**By beginning of May we sent to Legnaro 10 MC's:**

**For assembly on YB+2 top  
(Sep. To Nov)**

## PREVIOUS CABLE ROUTING

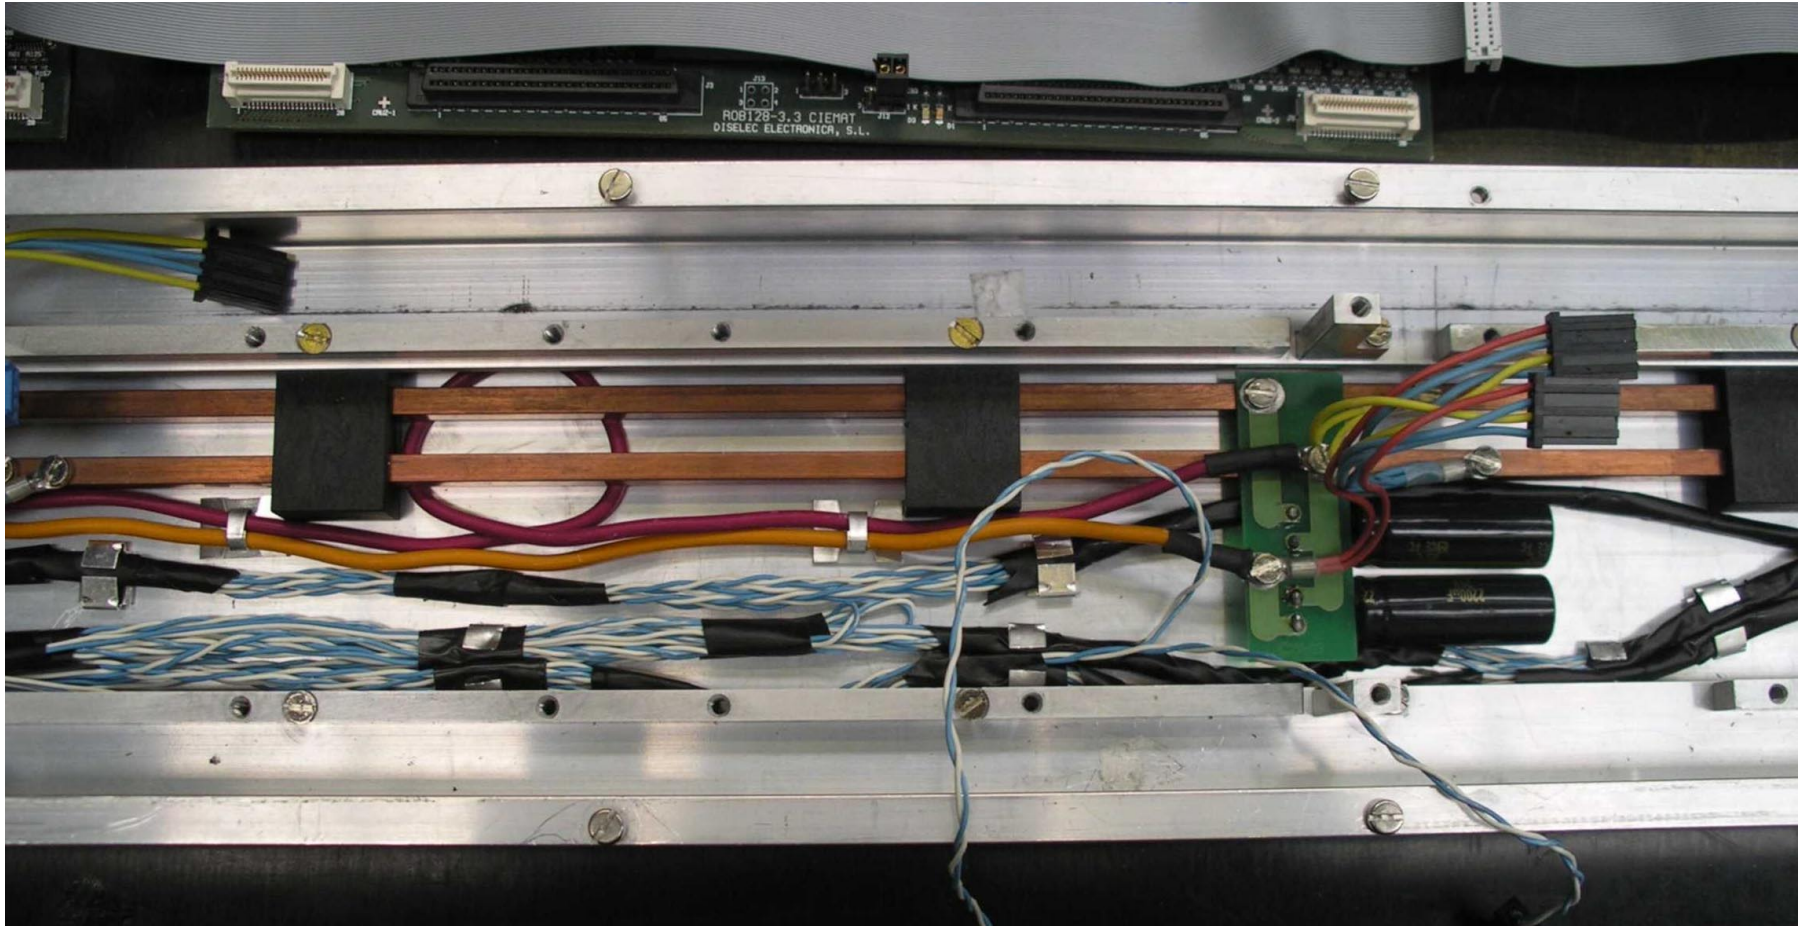
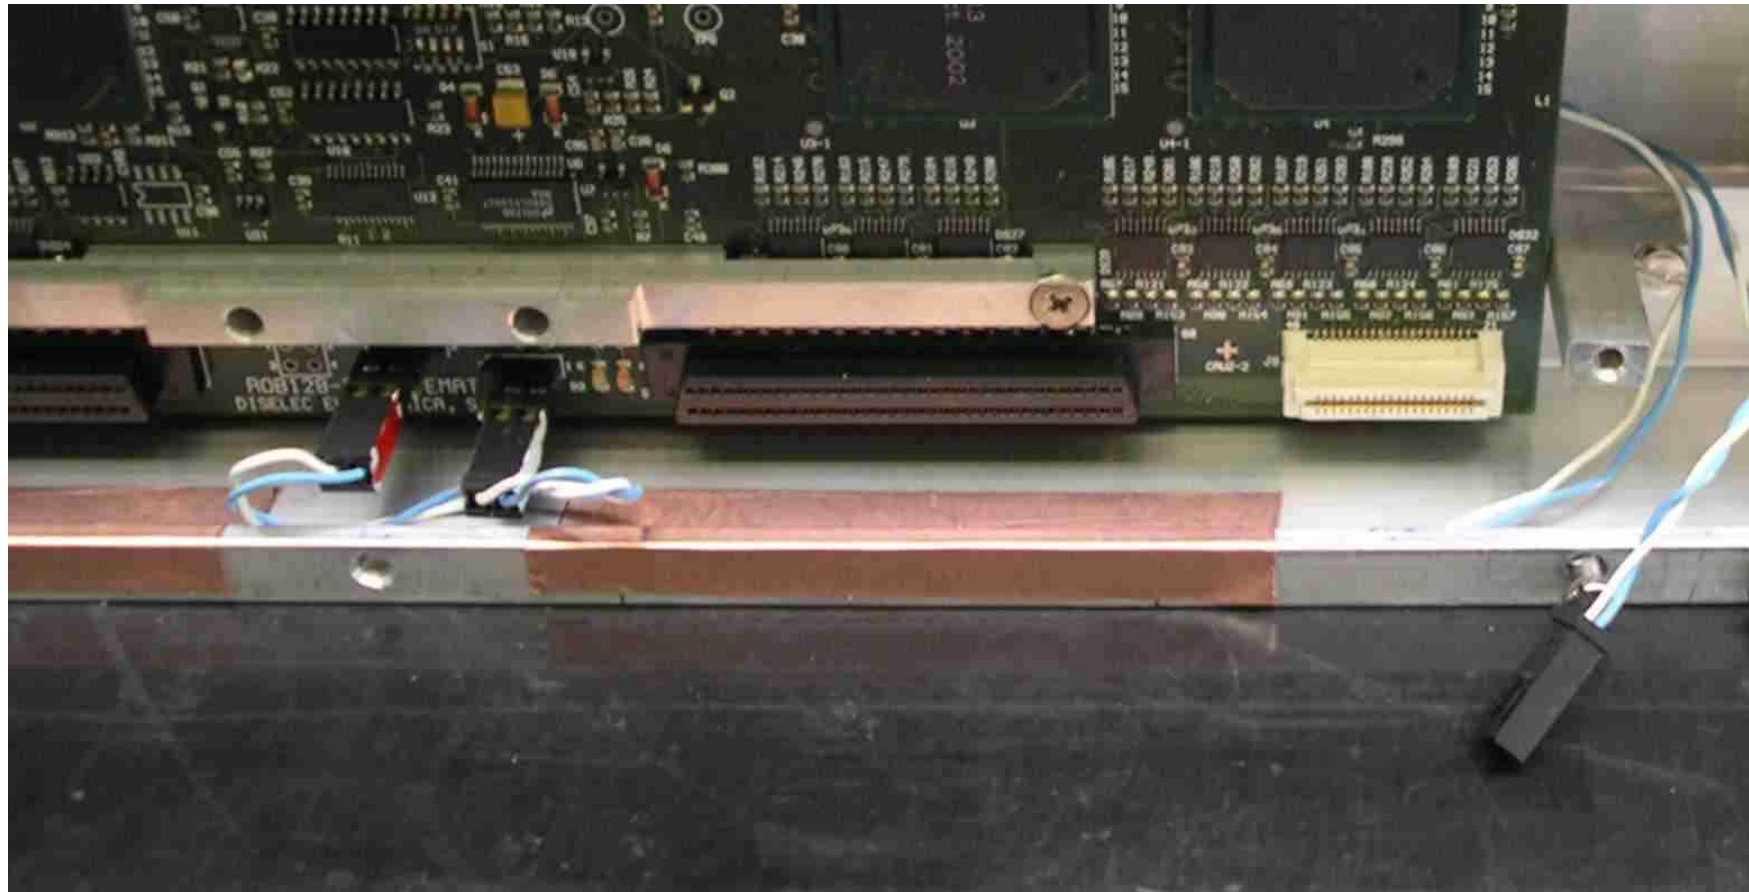
- **During first inspection Matteo and Lorenzo disagree on the way clock cabling was done. They argue that clock cable assembly procedure has to be reconsidered again, in order to minimize interference with front-end signals.**
- **They propose a different routing.**

- and include shielding of some parts of clock cables:

- **The conclusion is that all MC's now in Legnaro have to be dismantled to rewire clock cables.**
- **We offered to send to Legnaro 3 people to do this job.**
- **For the moment Lorenzo and Matteo are going to test a full final MC to check noise problems and fix final wiring.**
- **In Madrid we continue with mechanical assembly waiting for a final decision on clock cables.**
